Access Compliance Report

Public Rights-of-Way

Intersection ID: 30548	Main Street: CAROLINA_PAVILION_DR	Cross Street: SOUTH_BV	Location: SW
ADA ID: 1BA060B34B69	Ramp Type: Perp	Initial Pass/Fail: Fail	Overall Compliance: No
Severity Score: 33.75			
Codes/Mitigation Info/Possible Solution		Field Measurements/Component Compliance

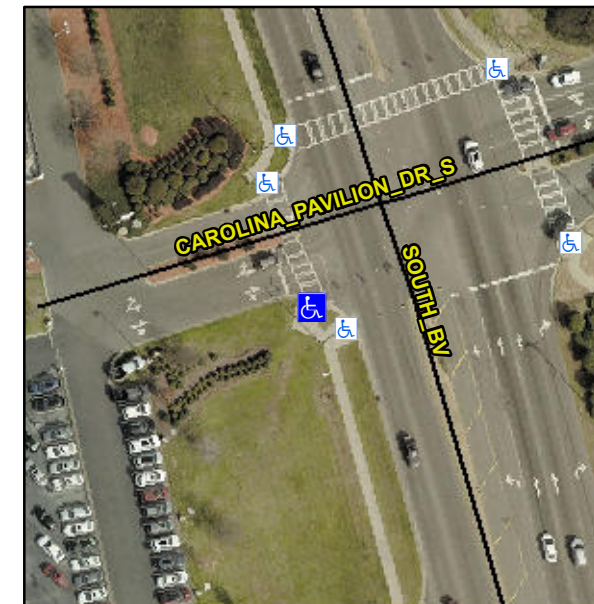
Not Found, R304.5.1, R304.5.3

Compliance	Description	Data	Compliance	Description	Data
N/A	Ramp Length (in)	134.0	Yes	Ramp Slope (%)	7.5
No	Ramp Width (in)	45.0	No	Ramp XSlope (%)	7.0
N/A	Flare Type LT	N/A	N/A	Flare Type RT	N/A
N/A	Flare Slope LT (%)	N/A	N/A	Flare Slope RT (%)	N/A
N/A	Flare Traversable LT?	N/A	N/A	Flare Traversable RT?	N/A
N/A	Landing Length (in)	N/A	N/A	DWS Provided?	N/A
N/A	Landing Width (in)	N/A	N/A	DWS Contrast?	N/A
N/A	Landing Slope (%)	N/A	N/A	DWS Length (in)	N/A
N/A	Landing X Slope (%)	N/A	N/A	DWS Full Width?	N/A
N/A	Landing Curb? (Y/N)	N/A	N/A	DWS Offset (in)	N/A
N/A	Shared Landing?	N/A			
N/A	Gutter Ponding?	N/A	N/A	Gutter Slope (%)	N/A
N/A	Gutter Lip Ht (in)	N/A	N/A	Gutter X Slope (%)	N/A
N/A	Painted X Walk1?	Yes	N/A	Painted X Walk2?	N/A
	X Walk 1 Direction	To N		X Walk 2 Direction	N/A
N/A	X Walk 1 Width (in)	106.0	N/A	X Walk 2 Width (in)	N/A
	X Walk 1 Slope (%)	1.3		X Walk 2 Slope (%)	N/A
	X Walk 1 X Slope (%)	5.3		X Walk 2 X Slope (%)	N/A

Remove & Replace Entire Ramp.
